# Camden Lock Village / Hawley Wharf

R016 - Area D Non Material Amendment Application

## 4.0 Area D

### Proposed Scheme - Fifth Floor Plan

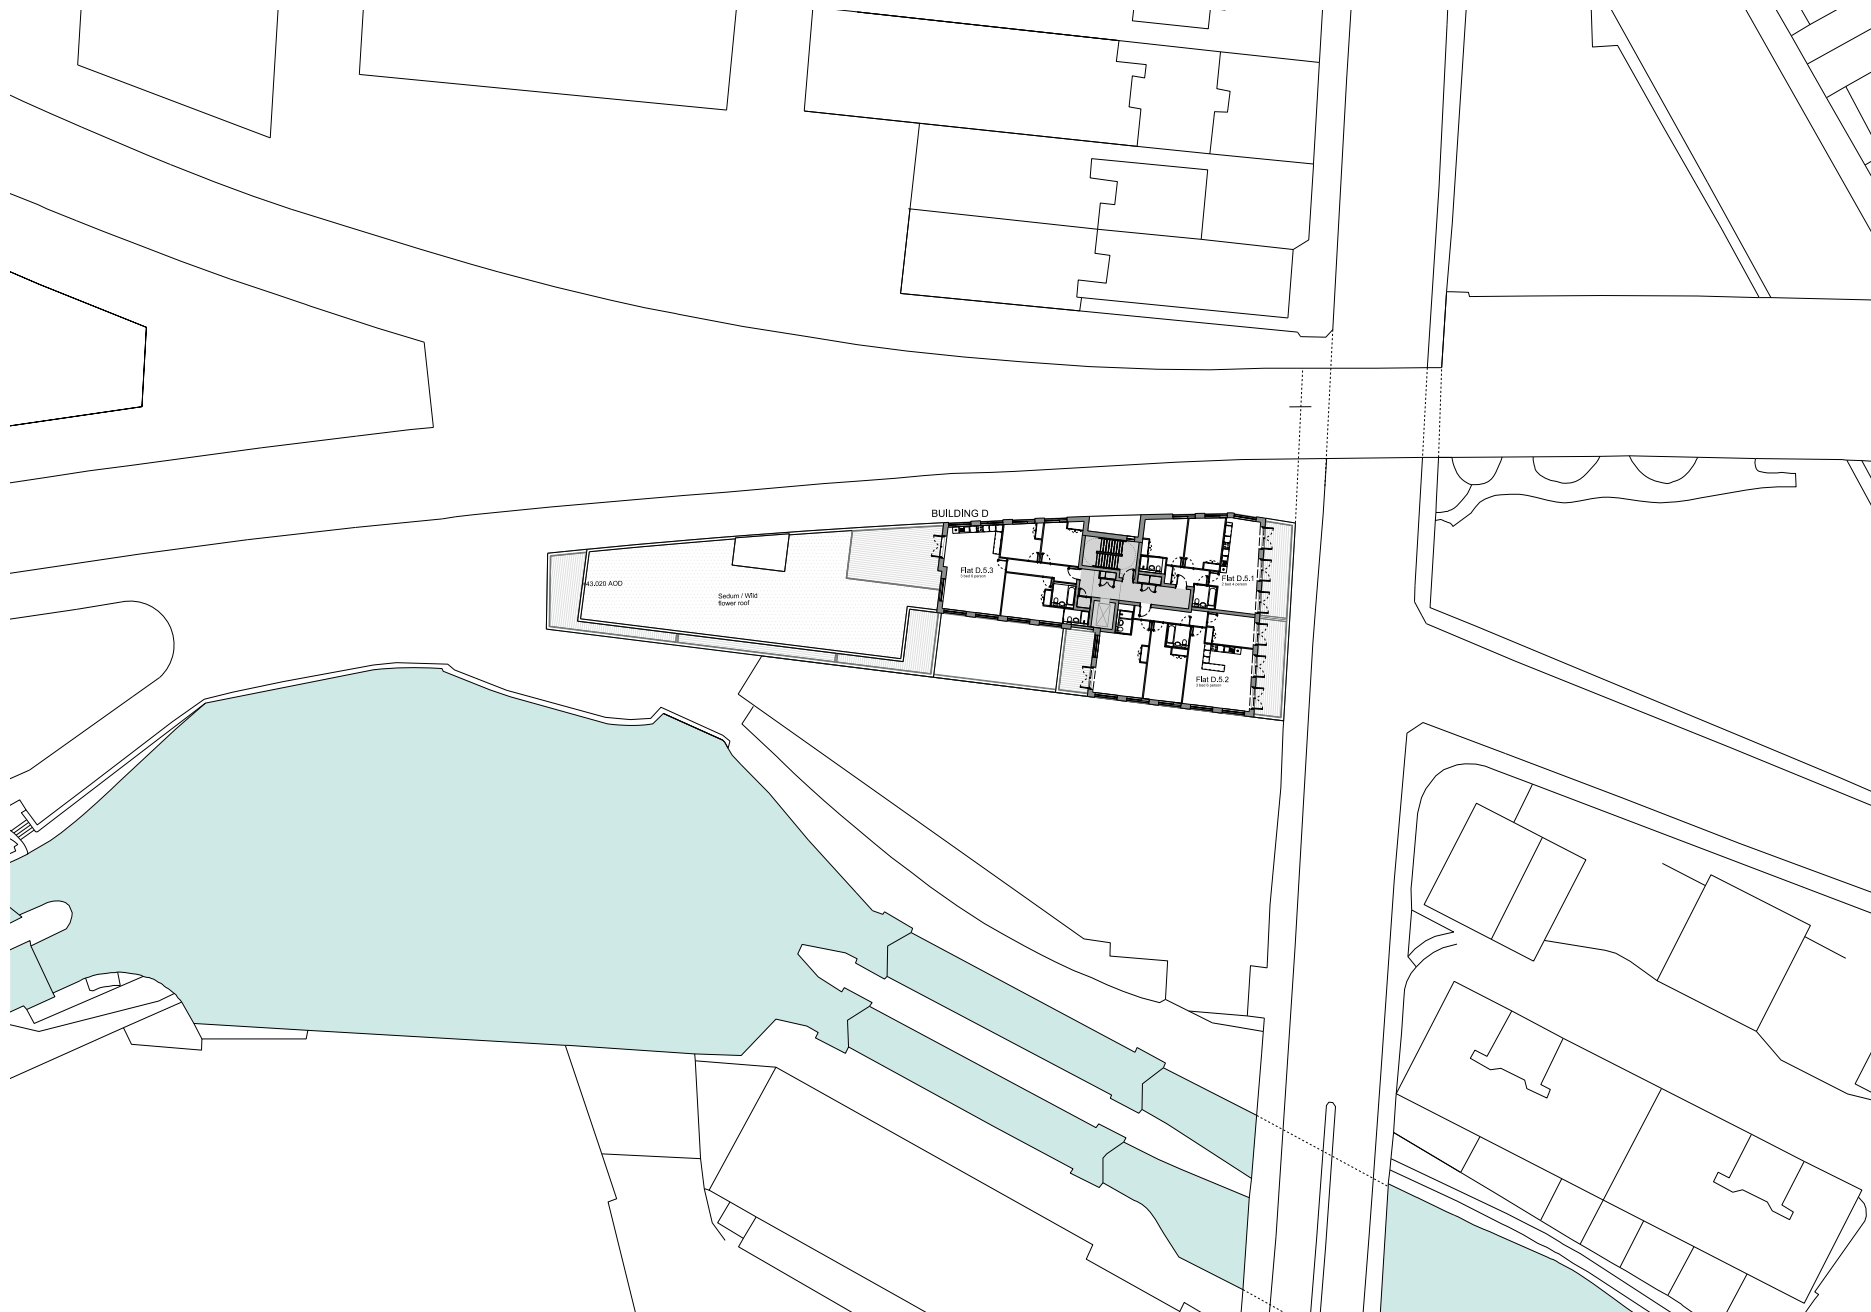
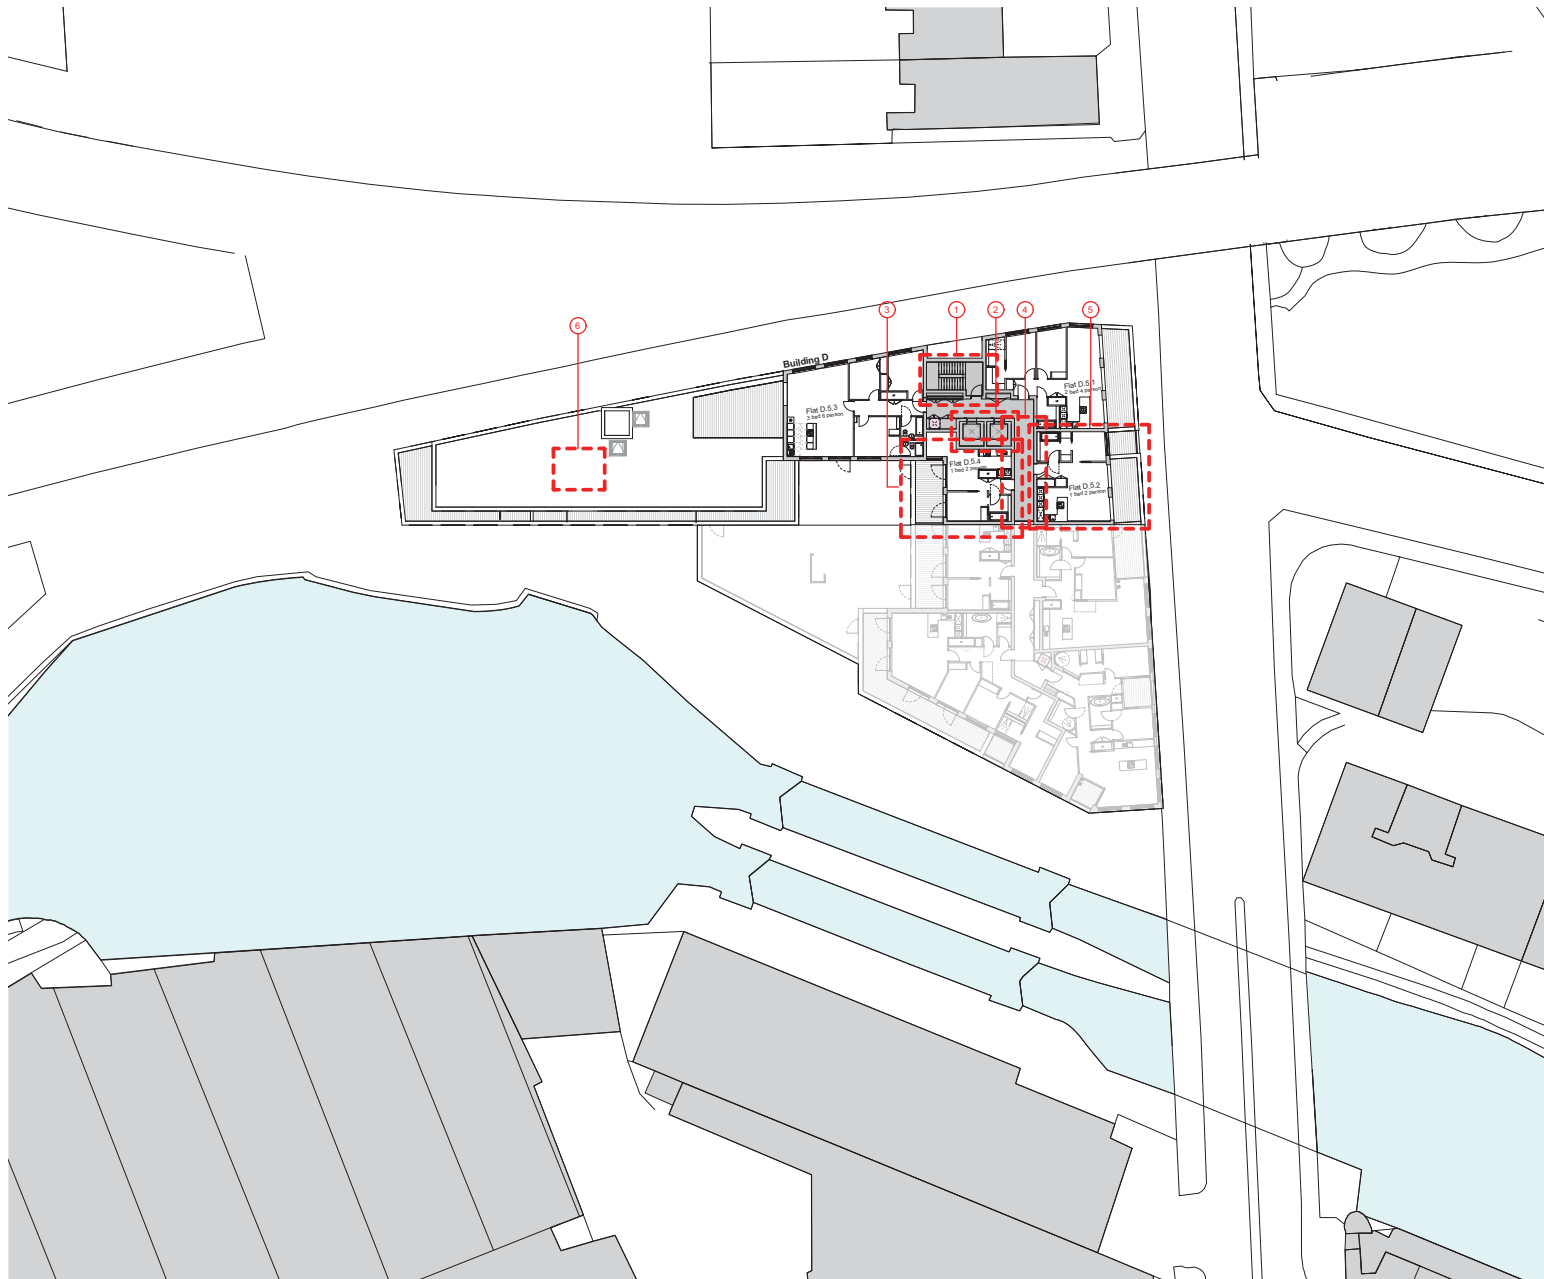
- ① Core revised and stair flipped to provide space for risers as per MEP service strategy
- ② Liftcore increased to accommodate Area E
- ③ New 1 bed 2 person flat added
- ④ Common corridor extended to accommodate Area E
- ⑤ Flat D.4.2 changed from 3 bed 6 person to a 1 bed 2 person apartment
- ⑥ New flue for cafe kitchen extract

- Structure added to plans
- Utility cupboards added to all flats as per updated MEP strategy

### 4.18 Proposed Scheme - Roof Plan

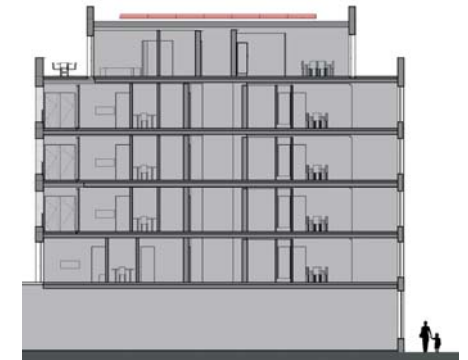
- ① PVs have been added to the roof and lift overrun increased in accordance with site wide M+E strategy.

Please refer to section below, which illustrates that the PVs will not be visible from the surrounding area.
